Re: NSTAR Electric Company d/b/a Eversource Energy, EFSB 16-02/D.P.U. 16-77

)	
Petition of NSTAR Electric Company d/b/a	)		
Eversource Energy and New England Power	)		
Company d/b/a National Grid for Approval to	)	EFSB 16-02/D.P.U. 16-77	
Construct, a New 115-kV Overhead/Underground	)		
Transmission Line in West Roxbury, Dedham, and	)		
Needham Pursuant to G.L. c 164 § 69J and § 72	)		
	)

Information Request TON-1-1

**Graph of Magnetic Fields (MF) in Milligauss (mG) at Three Feet Above Grade,
for Underground (UG) Line Segments at Various Depths (Average Loading)**

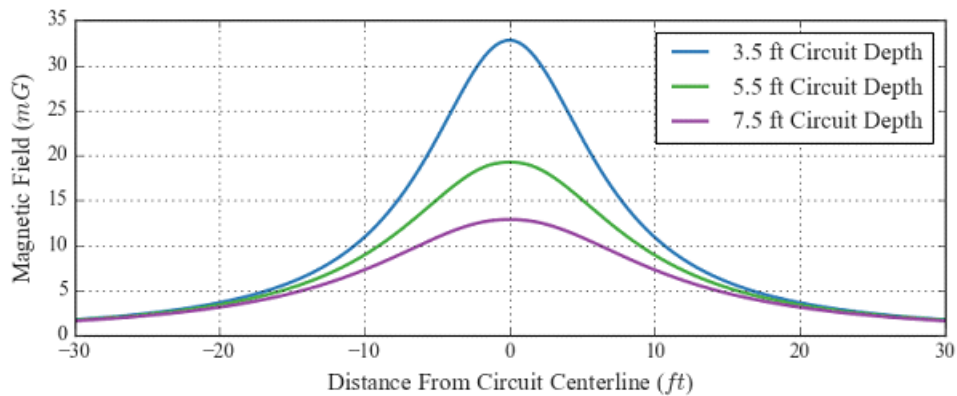
- (f) Please provide a copy of the results of EMF modeling analysis using the depth placement for the duct bank specified in your response to TON-1- 001(e).

- (f) The actual depths of the underground duct banks in Needham are not yet known as the profile design has not been completed. However, the EMF modeling was done for the shallowest anticipated duct bank depth, namely, where the uppermost 115-kV phase conductors in the duct bank are located at 3.5 feet below grade. The EMF

modeling analysis therefore yielded the highest anticipated magnetic fields (“MF”) above the duct bank (as given in Figure 3.6 of the Gradient EMF Report (Petition, Vol. II, App. 5-8)).

A duct bank identical to Needham’s has been proposed for a Project for an underground (“UG”) transmission line that connects a substation in Woburn to one in Wakefield (EFSB 15-04 / D.P.U. 15-140/15-141). An Information Request response in the record for that project (Exh. TOS-ED-10) provided the distribution of duct-bank depths for UG lines traversing streets in towns similar to what would be expected in Needham.

The response to Information Request TOS-ED-10 on duct bank depths showed that for about 65 percent of the route, the depth to the uppermost conductors was more than 5 feet, and for about 50 percent of the route, the depth to the conductors averaged 7.5 feet. The following graph shows the MF for average load levels for duct bank depths to the uppermost conductors of 3.5 feet (shallowest, Fig. 3.6 of the EMF Report), 5.5 feet, and 7.5 feet. The table after the graph gives numerical results for the peak MF, MF at ± 20 feet either side of the circuit centerline, and the percentage reduction in MF at these locations that would be expected from increased duct depth.

Notably, for MF directly above the duct bank, increasing the depth decreases the MF by about 40 percent for every 2-foot increase in duct bank depth. But, the decrease in MF at locations lateral to the circuit centerline is less. That is, at ± 20 feet to either side of the centerline, MF decreases only about 7 percent for every 2-foot increase in duct bank depth. At larger lateral distances, the percentage decrease is even less.

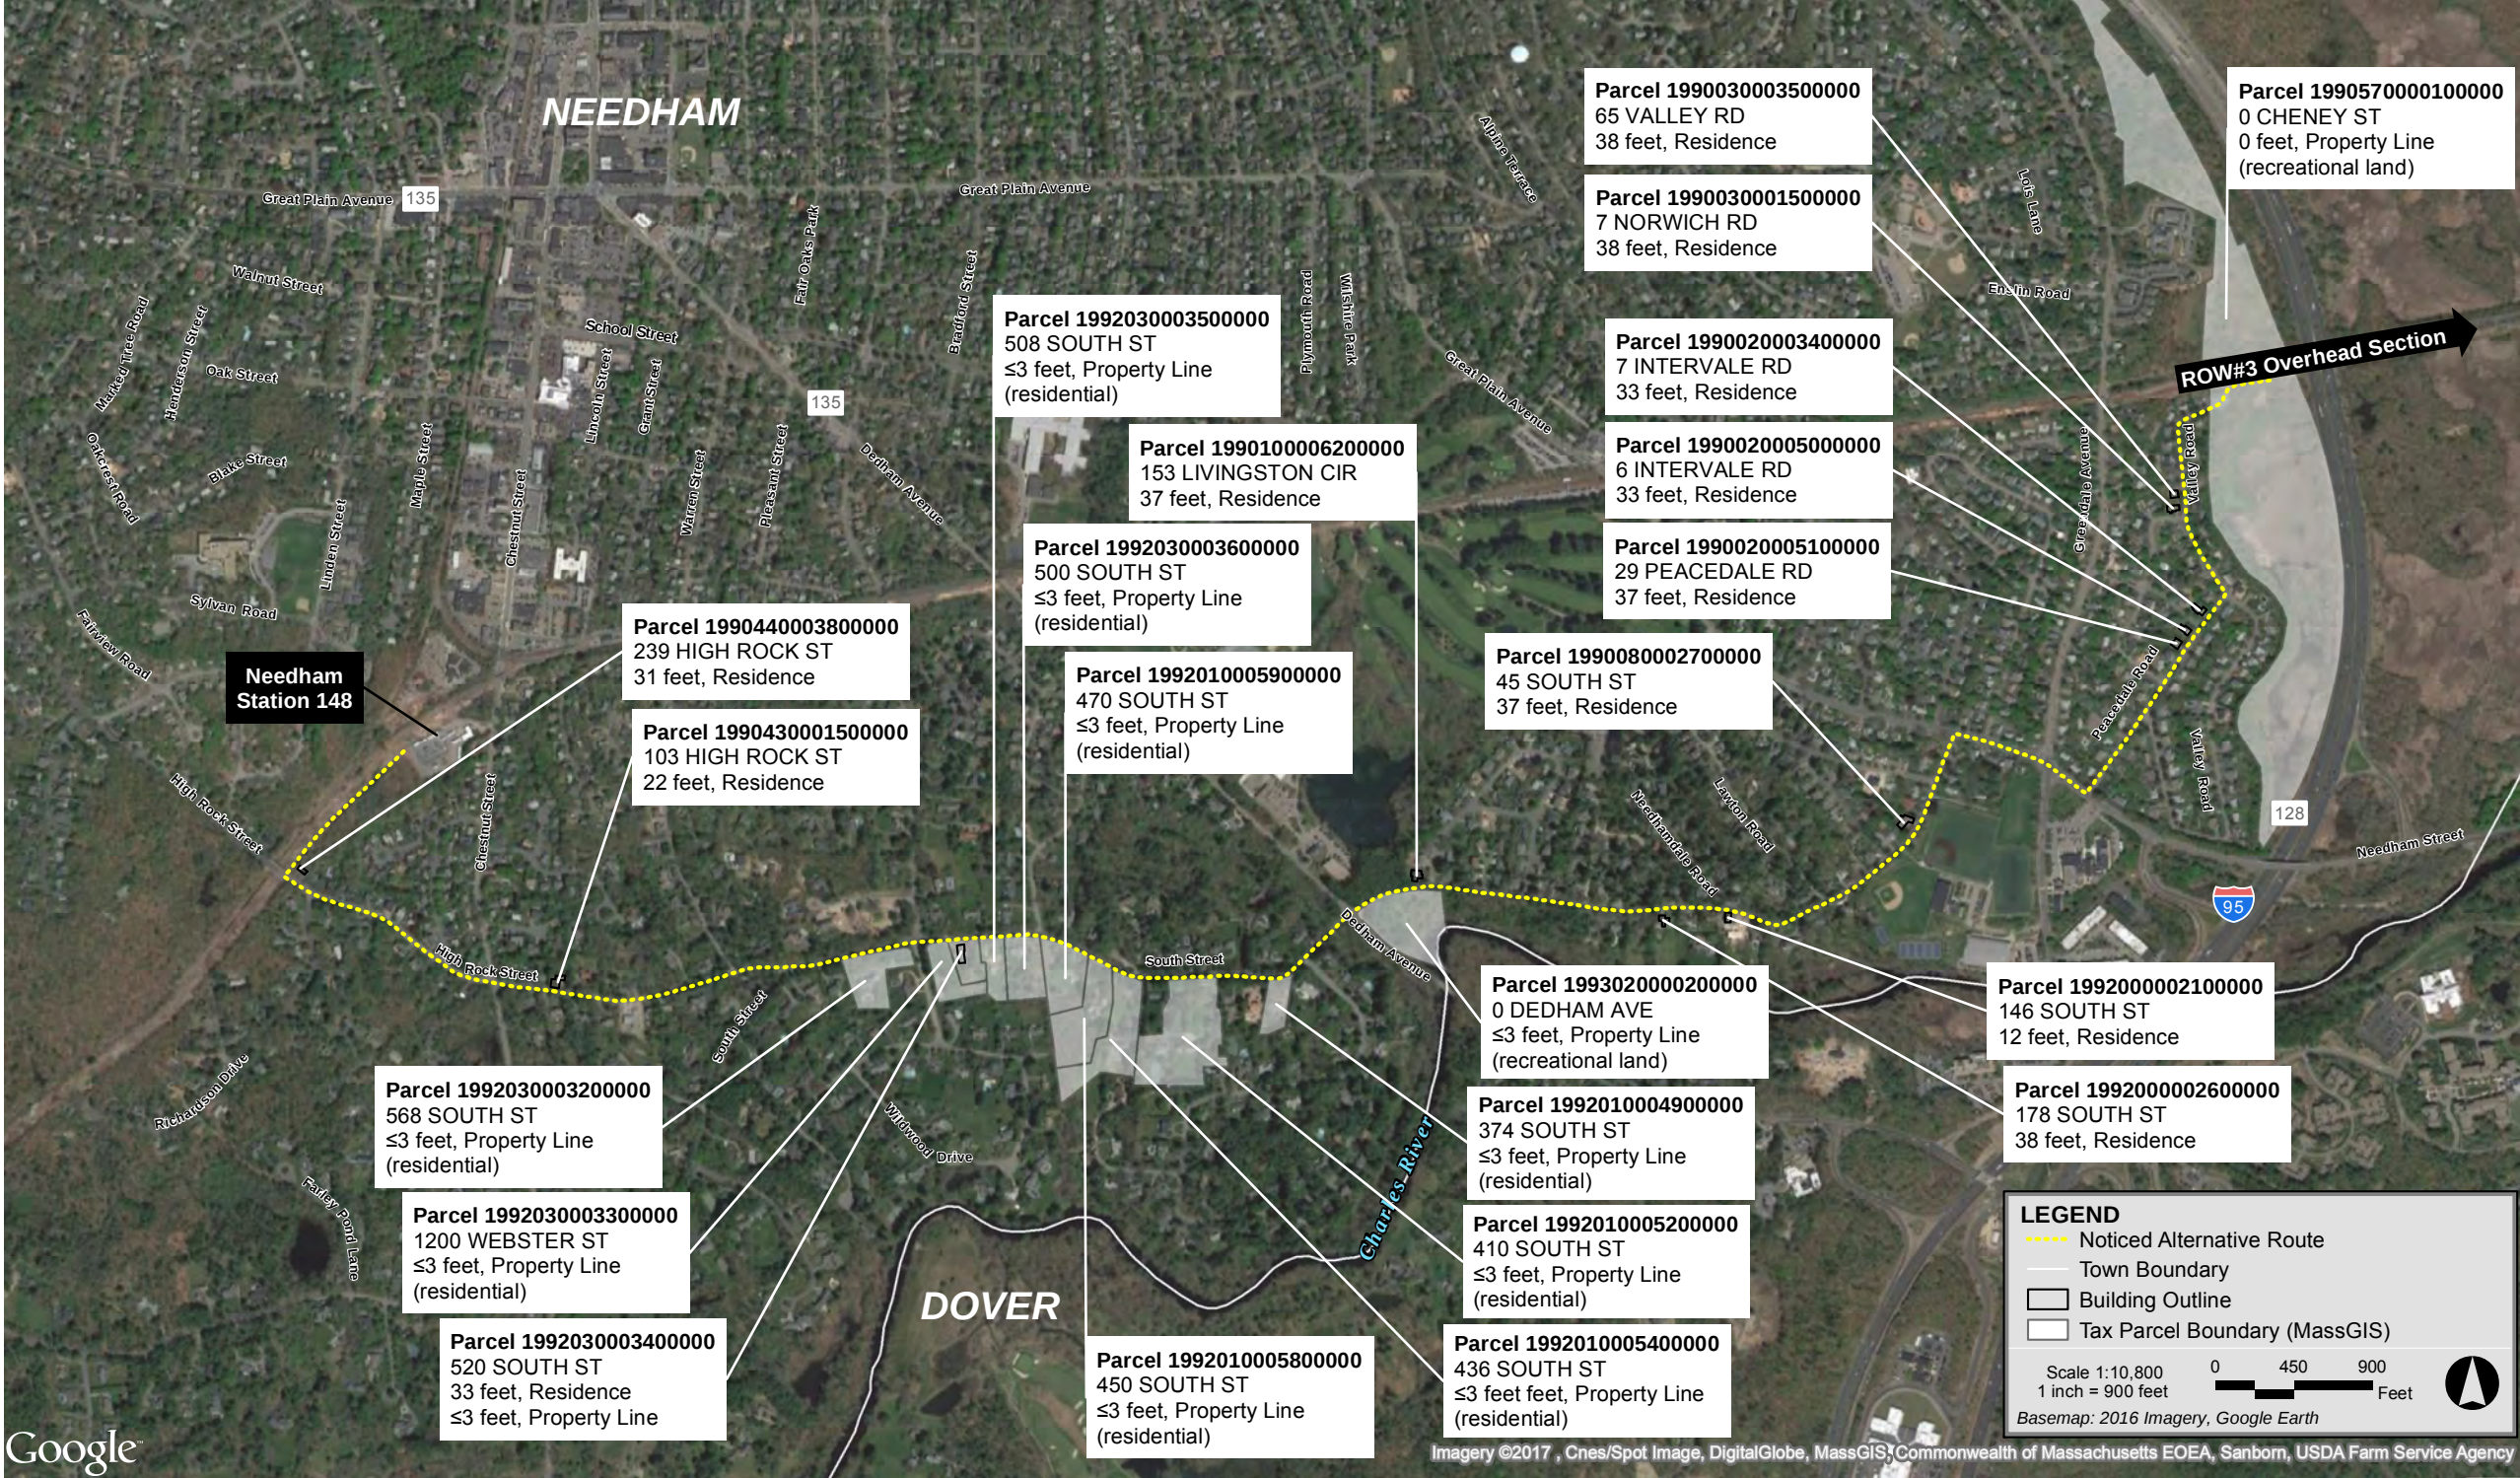
For each of the 12 narrowest points along both the Company's preferred transmission route and its noticed alternative route, please provide the distance between the proposed location of the conduit and;

- (a) The nearest property line;
- (b) The nearest building foundation; and
- (c) The nearest residential building foundation.

In your response, please identify the points along each route that were utilized for such measurements; property information, including Assessors' Map and Lot designations, for each property line utilized for such measurements; and the address and current use of the buildings utilized for such measurements.

Attachment TON-1-3(1) depicts the 12 nearest property lines, building foundations (regardless of use) and/or residential building foundations to the approximate centerline of the proposed underground cable along with the other requested information (map and parcel, address, current use, etc). These measurements are based on GIS mapping data and are therefore considered approximate. Please also note there is some overlap between the referenced features; for example, 10 of the 12 nearest building foundations are also residential building foundations and four of the nearest building foundations are also located on the nearest property line.

Attachment TON-1-3(2) includes the same requested information for the Noticed Alternative Route. Because the Company does not have a preliminary design prepared for the Noticed Alternative Route that could be relied upon to obtain the requested measurements from the cable location, the Company relied upon the centerline of each street as a proxy for where the cable might be installed. As with the data presented on Attachment TON-1-003(1), these measurements are based on GIS mapping data and are therefore considered approximate. Please note that there are no building foundations (regardless of use) located closer to the Noticed Alternative Route's estimated cable location other than residential building foundations.

TON 1-4

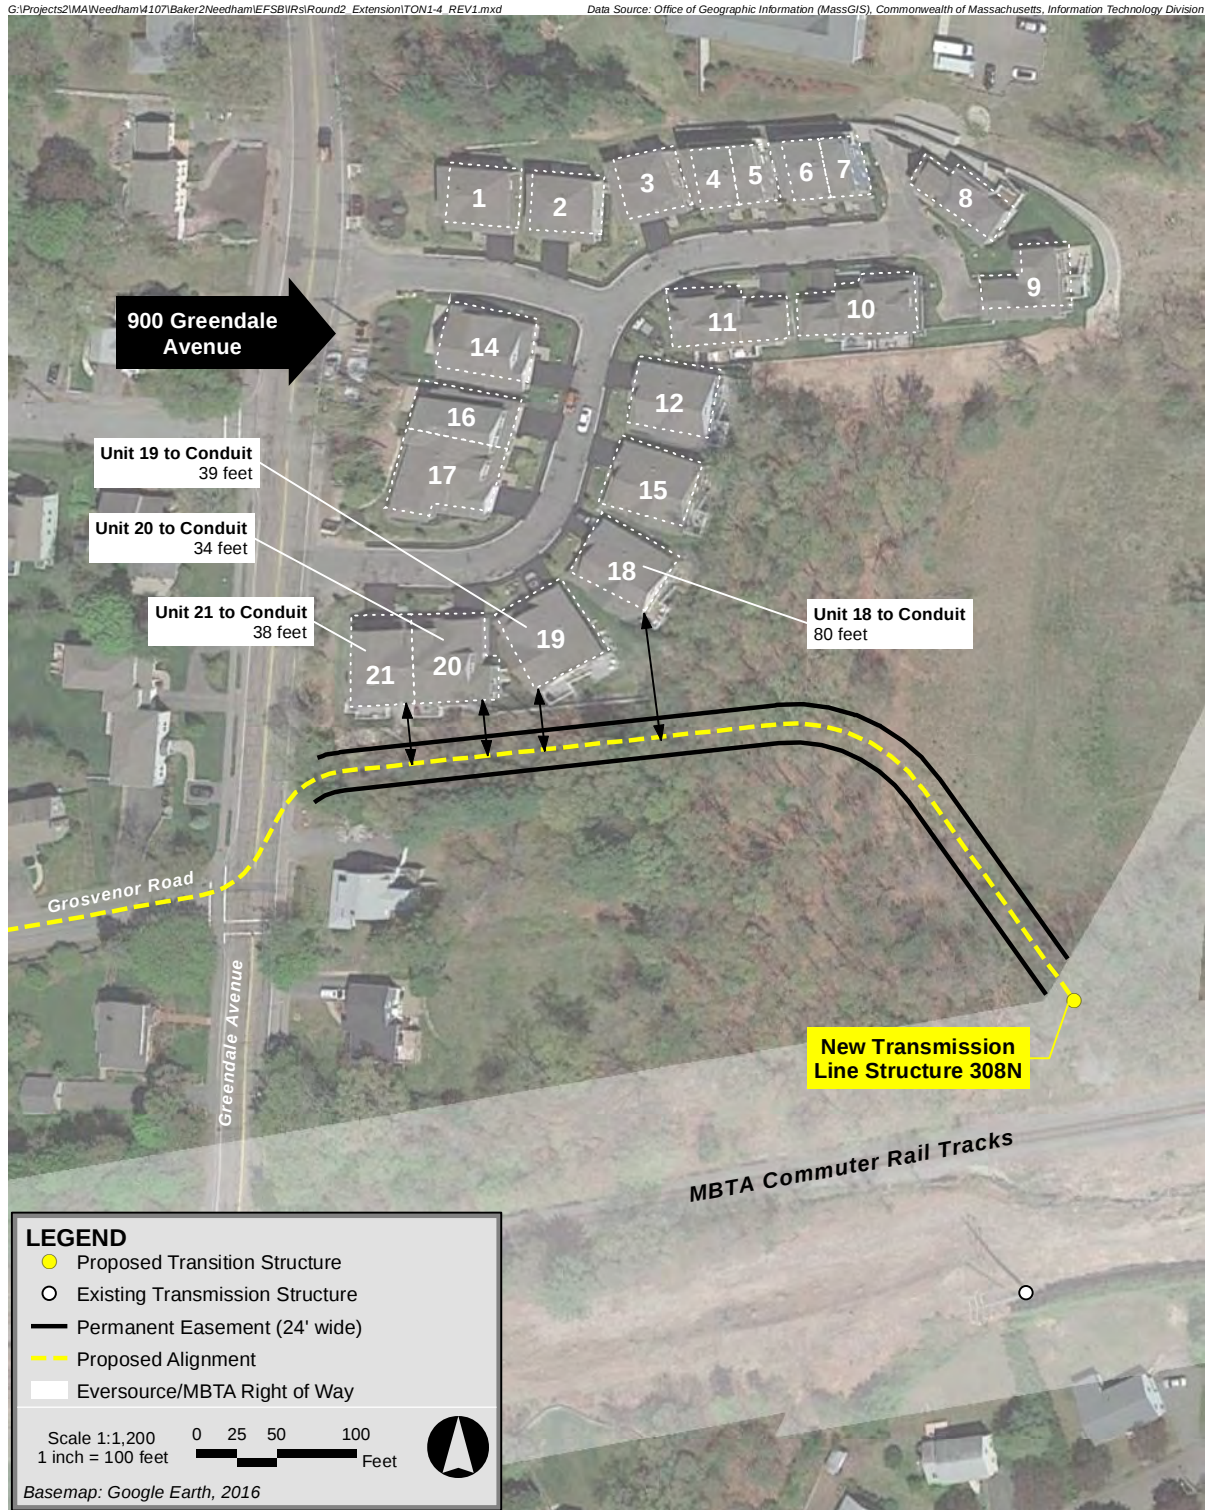
Please refer to your response to EFSB-LU-14. Please provide the distance between the actual proposed location of the conduit within the proposed route ROW and the 900 Greendale Avenue units referenced in your response.

The requested measurements are provided on Attachment TON-1-4(1).
